TF-BTA 7th Meeting

Assessment of Proposals for the Determination of the Test Area and the Test Execution

**on behalf of the
VDA ad-hoc Working Group Pedestrian Protection**

2. Use Smaller Corner Gauges?

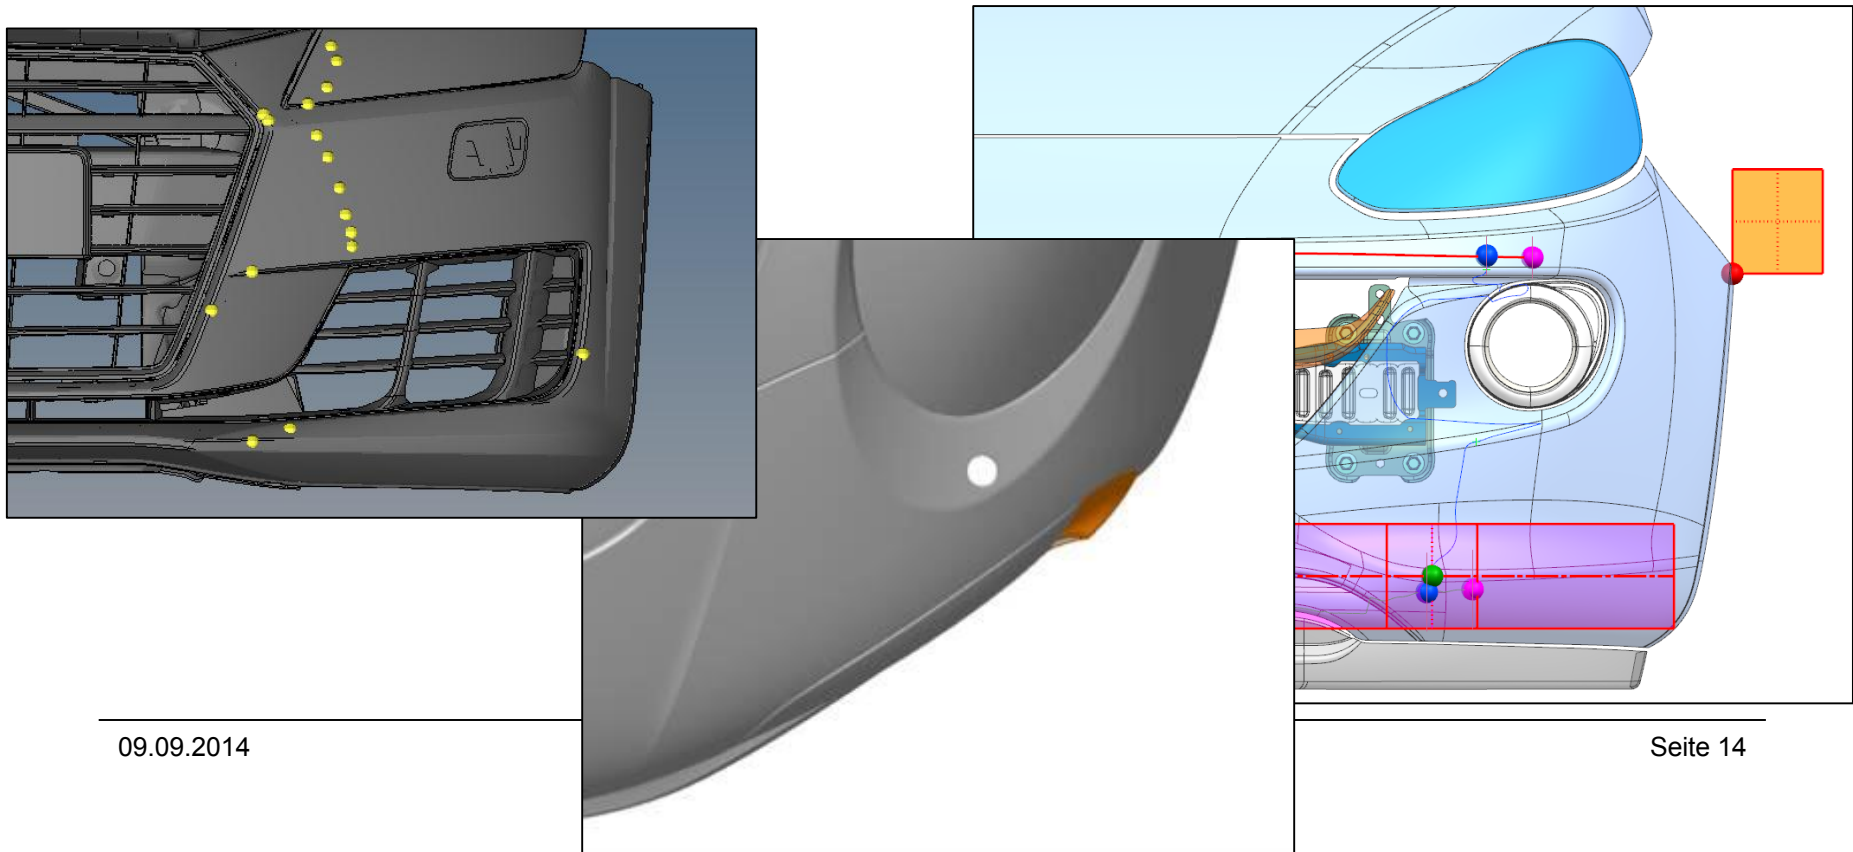
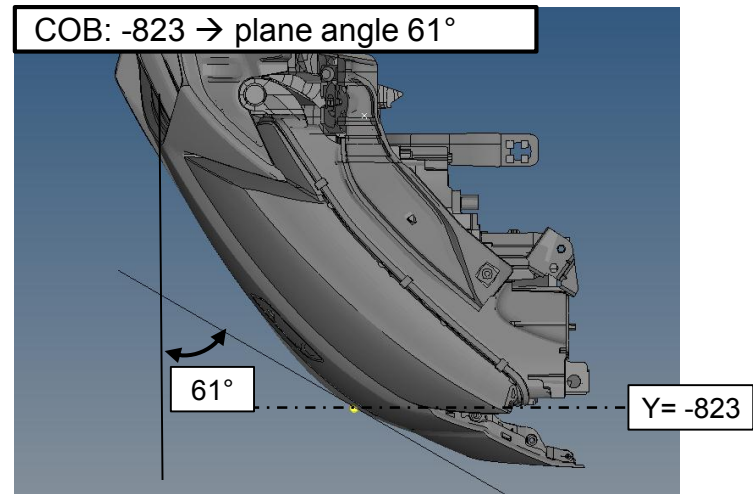
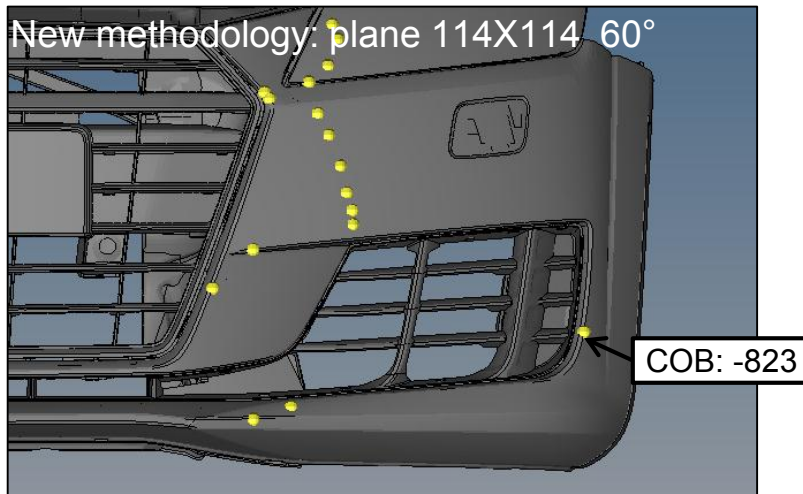
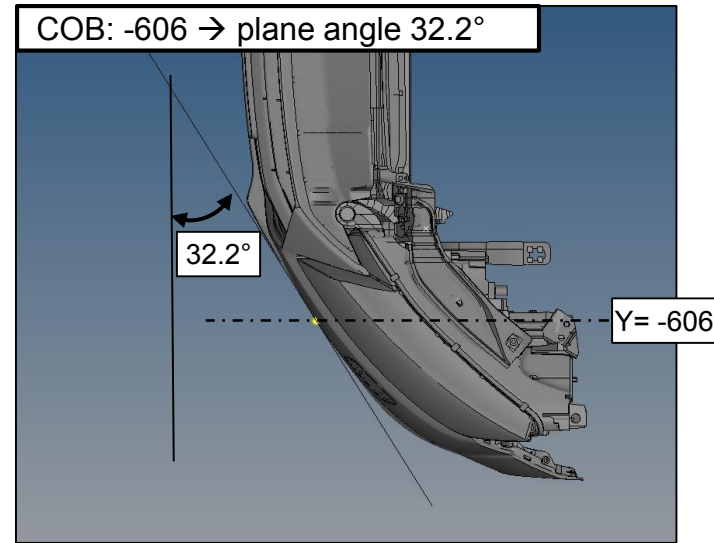
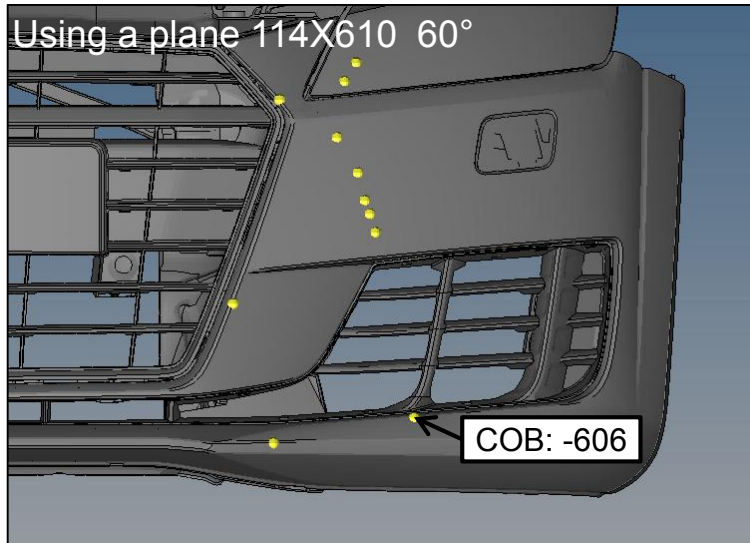
- Finally, if small styling features are to be assessed, the issues with the FlexPLI rotation still exist (see documents TF-BTA-3-03r1, TF-BTA-3-07, TF-BTA-3-08, TF-BTA-4-03, TF-BTA-7-07) since the legform just assesses the “global” surfaces

3. Define Test Area over the Full Vehicle Width?

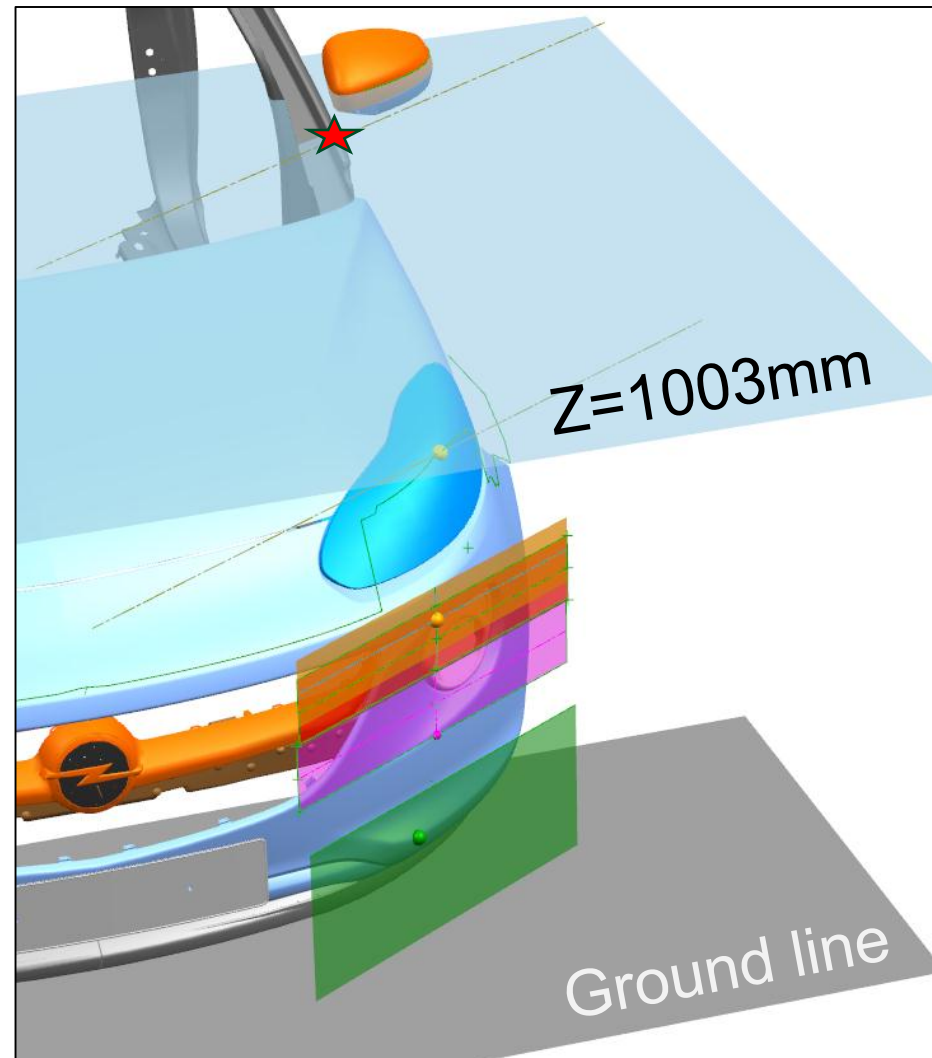
- Height limit of touch points according to FlexPLI dimensions will lead to issues with non-lower leg related vehicle parts like A-pillars, mirrors or tires (example 1).

3. Define Test Area over the Full Vehicle Width?

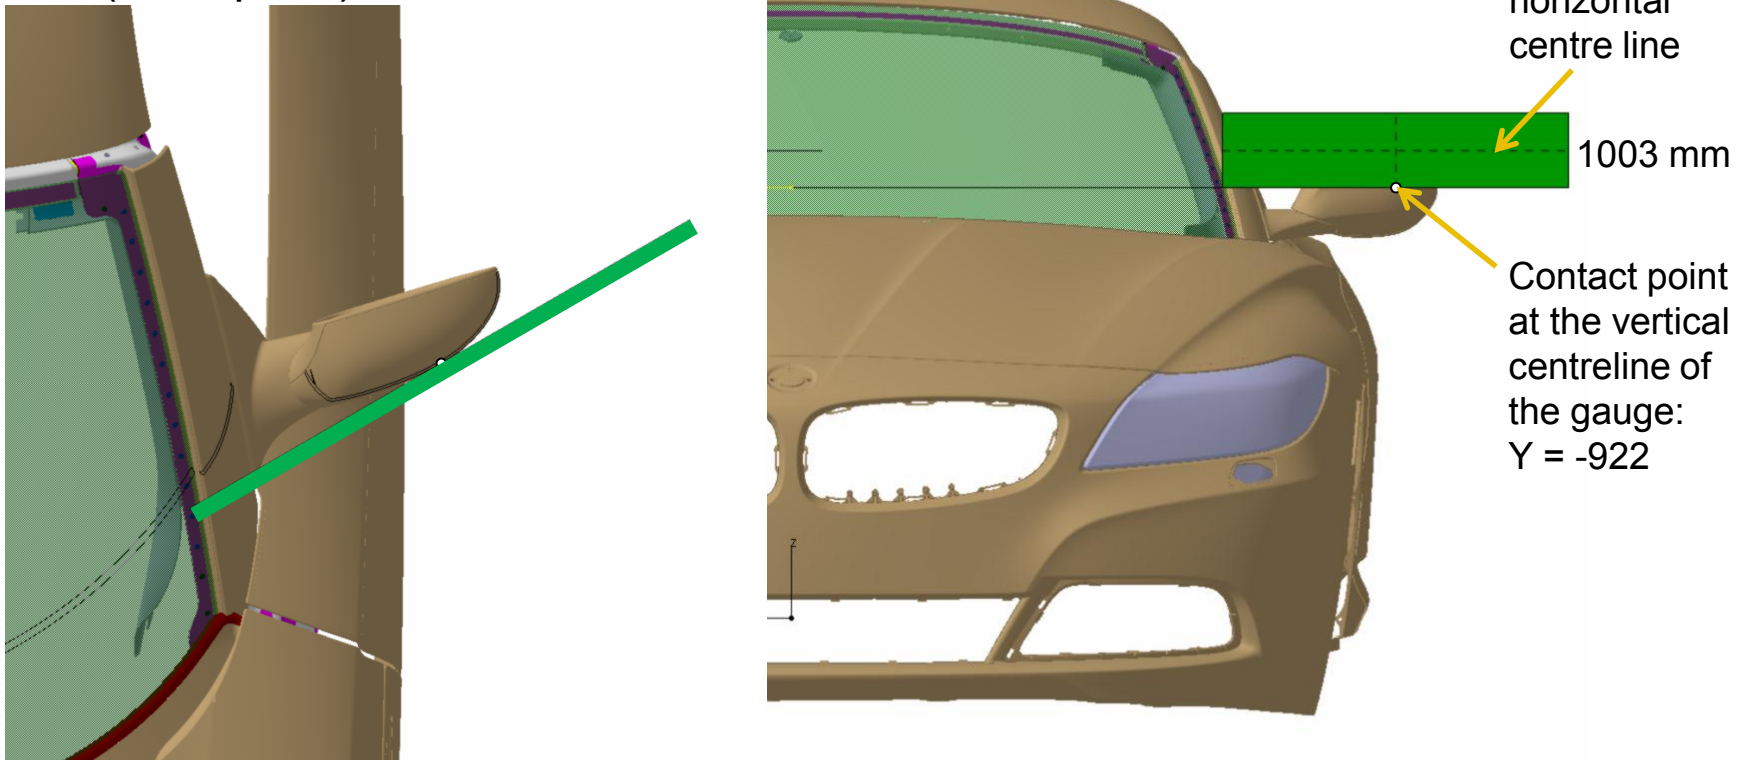
- Height limit of touch points according to FlexPLI dimensions will lead to issues with non-lower leg related vehicle parts like A-pillars, mirrors or tires (example 2).

3. Define Test Area over the Full Vehicle Width?

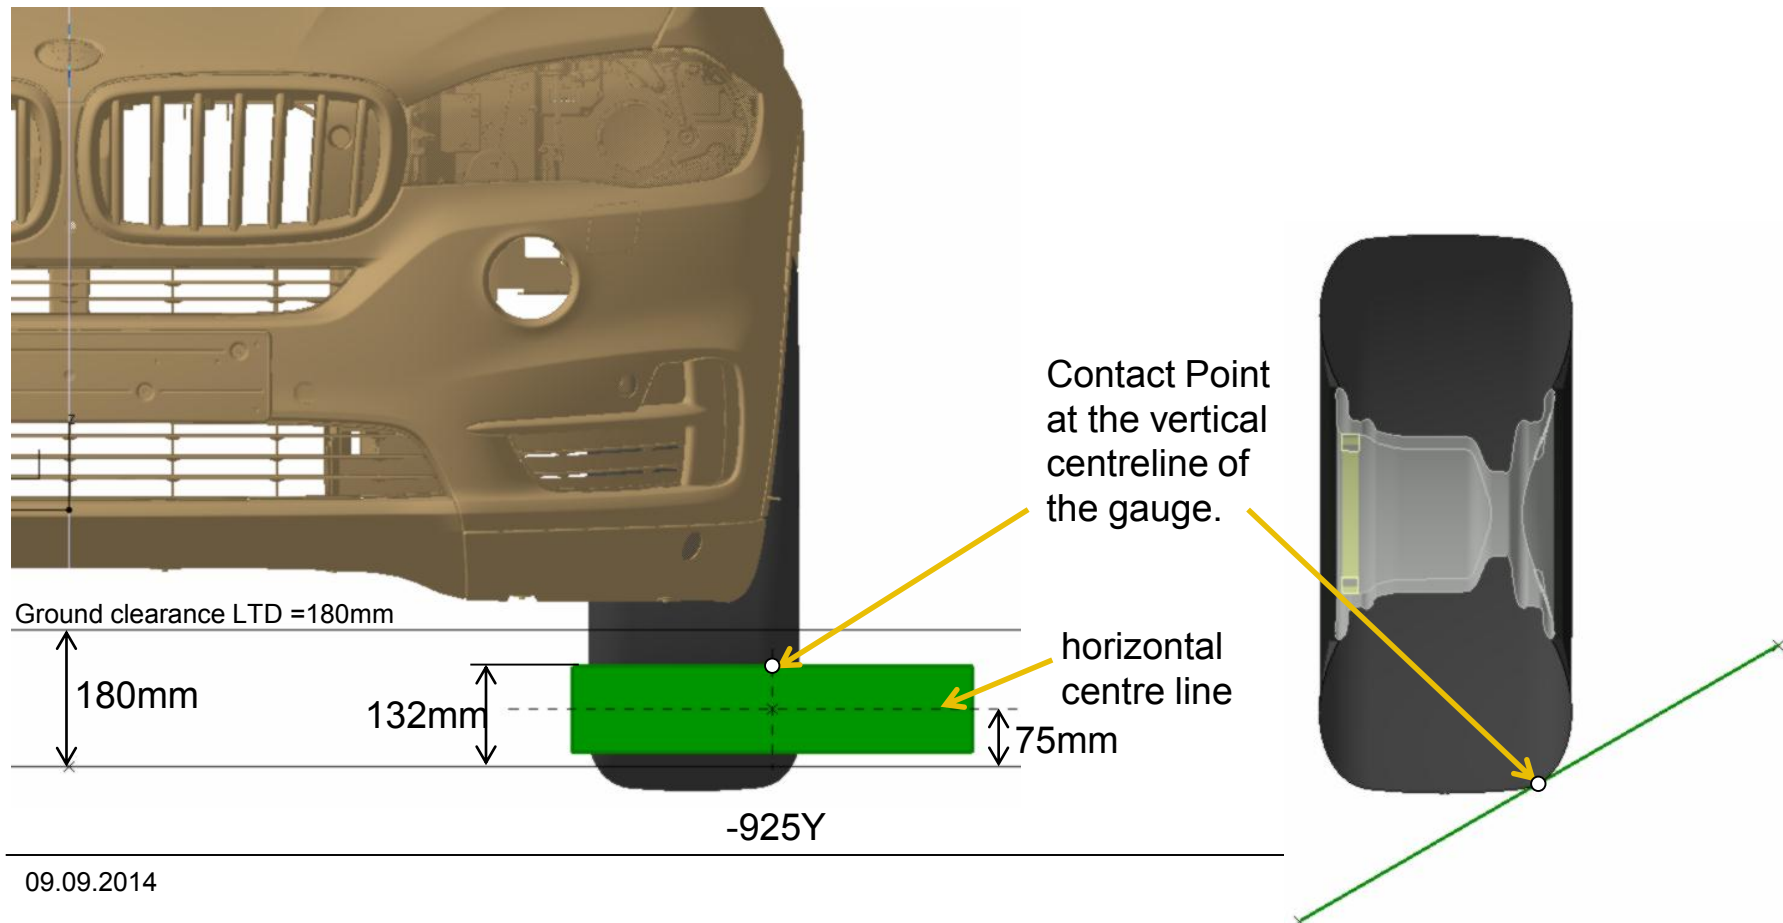
- For SUV's, wheels are within the test area
